**Our Case Number:** ABP-314438-22

**Re:** 2 semi-detached dormer bungalows with access from Newlands Park for vehicular parking; car parking, landscaping and boundary treatments and associated site works  
13 Newlands Drive, Clondalkin, Dublin 22

## FIRST PARTY APPEAL

### AGAINST SOUTH DUBLIN COUNTY COUNCIL DECISION TO REFUSE PLANNING PERMISSION FOR DEVELOPMENT AS DESCRIBED BELOW

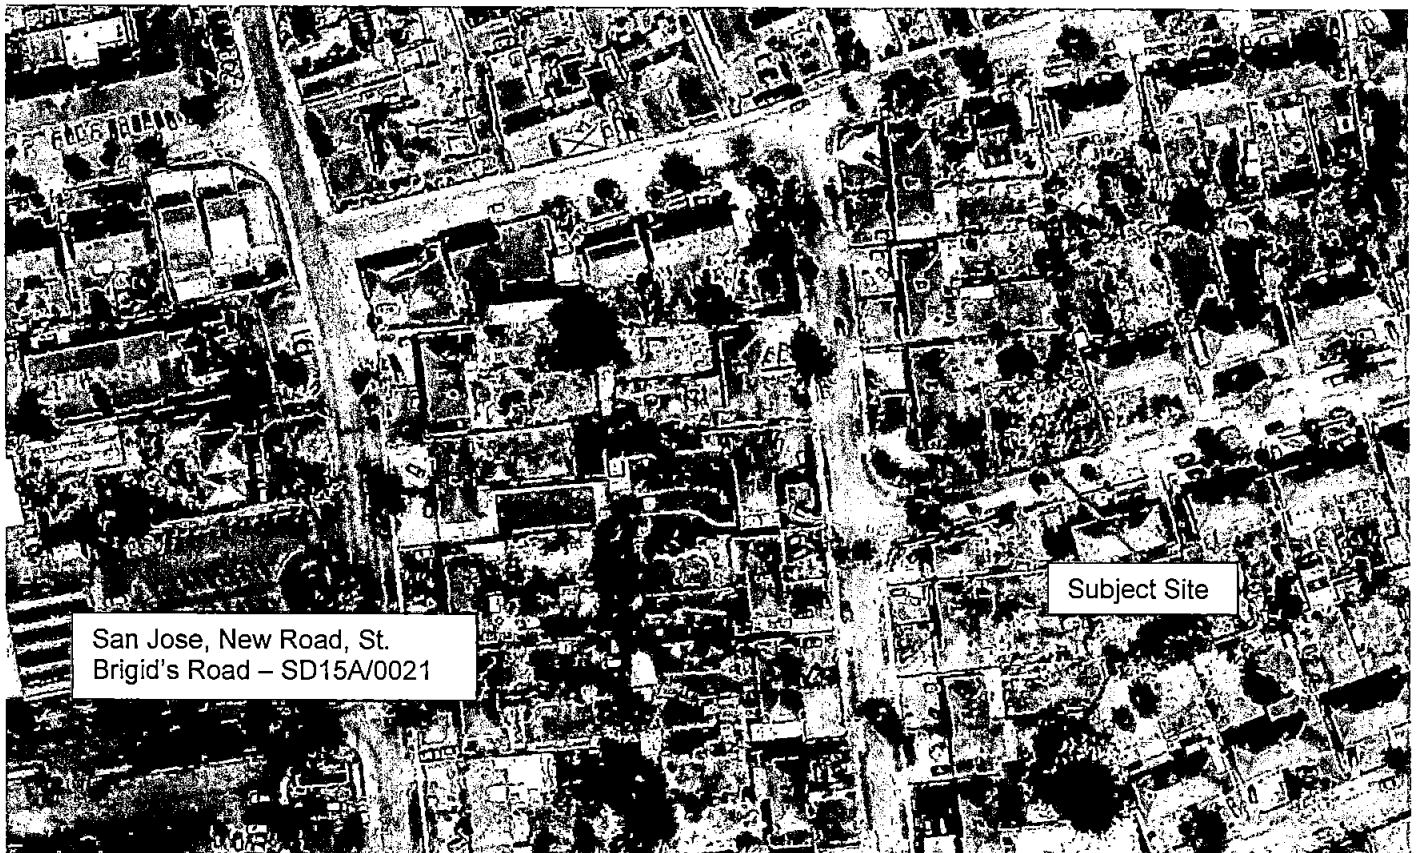
*The proposed dwellings, by reason of their design, scale and proximity to the northern site boundary with the immediate neighbour to the north, would be overbearing and visually dominant when viewed from the rear garden of the immediate neighbour to the north and lead to unacceptable levels of overlooking into this neighbouring rear garden. Accordingly, the proposed development is considered to contravene Section 11.3.2 (ii) Corner/Side Garden Sites of the South Dublin County Development Plan 2016-2022 and the zoning objective for the area which seeks 'to protect/and or improve residential amenity', would seriously injure the amenity of property in the vicinity and would contravene the proper planning and sustainable development of the area.*

By way of addressing the council's concerns in relation to scale, height and impact on the property and garden to the north of the subject site, we have proposed for An Bord Pleanála's consideration, 2no. angled windows to bedrooms at first floor level, to direct line of sight away from the property to the north (No. 15 Newlands Drive). Please see below extracts from first floor layouts of the original submission, and the revised submission, full drawing can be seen under Appendix E, which accompanies this appeal document.

It should be viewed that these proposed changes alleviate the concerns SDCC have in relation to the impact on the property to the north, which could have been dealt with by way of additional information or by way of condition, for submitting to the council prior to commencement.

Extract from subject application drawings under SD22A/0155

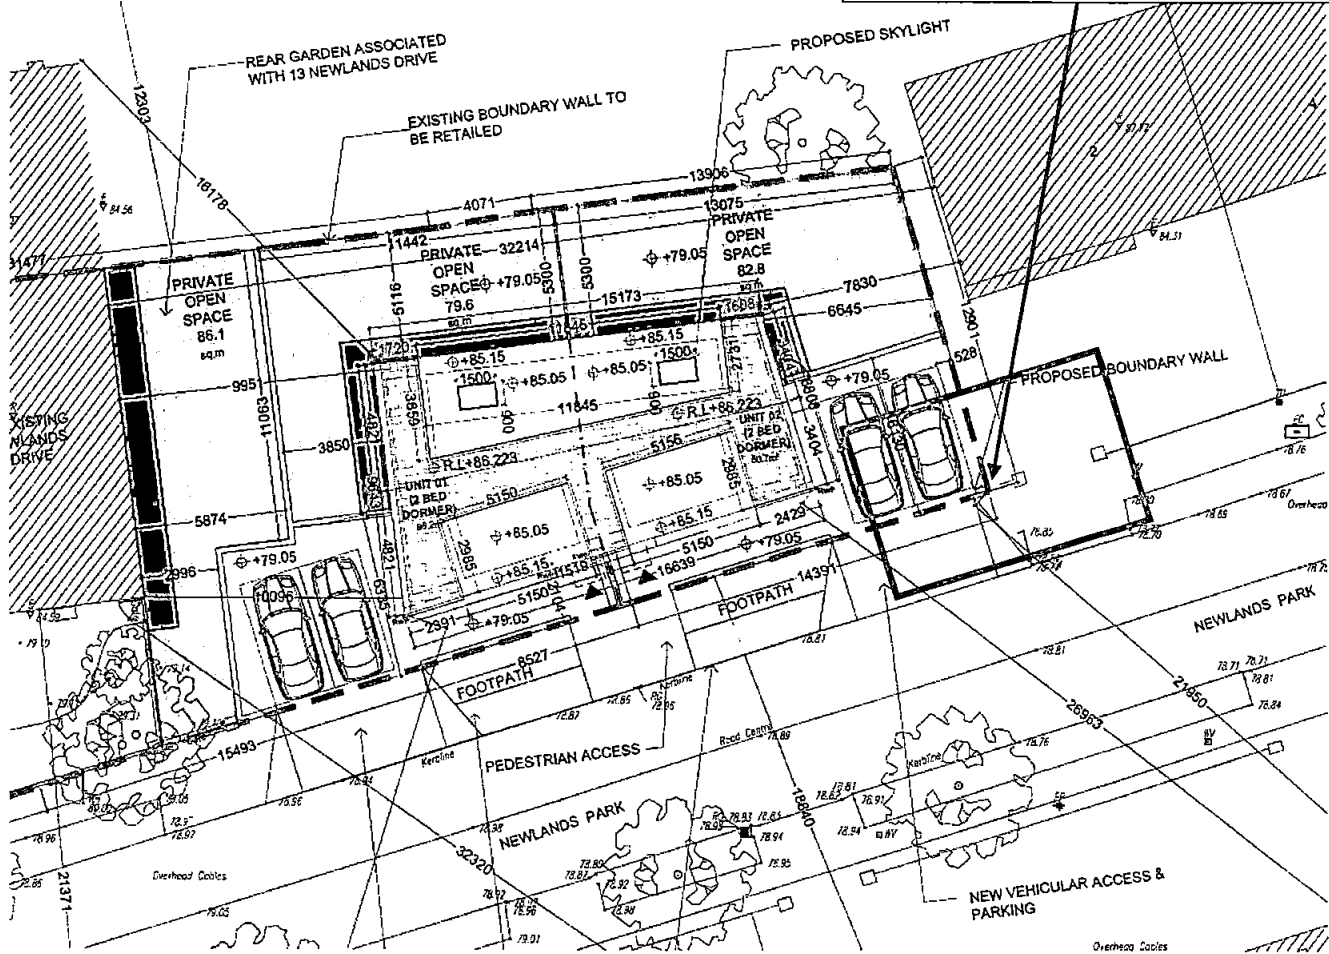
*The addition of two more vehicular access points in close proximity to existing vehicular access points along Newlands Park would lead to an intensification of traffic accessing and egressing within a relatively short distance, which may endanger public safety by reason of a traffic hazard. Insufficient information has been submitted in relation to visibility splays to the satisfaction of SDCC's Roads Department. The proposed development would not accord with the proper planning and sustainable development of the area.*

*"There would be 2 no. onsite car parking spaces provided for each dwelling. This level of car parking is acceptable to the Roads Department and the Planning Authority. A vehicular access would be constructed for each dwelling (2 no. new accesses from Newlands Park). The proposed vehicular access for Unit 01 is located directly adjacent to an existing vehicular access to the site from Newlands Park. This is not acceptable, and the proposed access would either need to be moved or the existing access removed.*

Note new vehicular access to Unit 02 has separation of 1.5m to the access from No. 2 Newlands Park
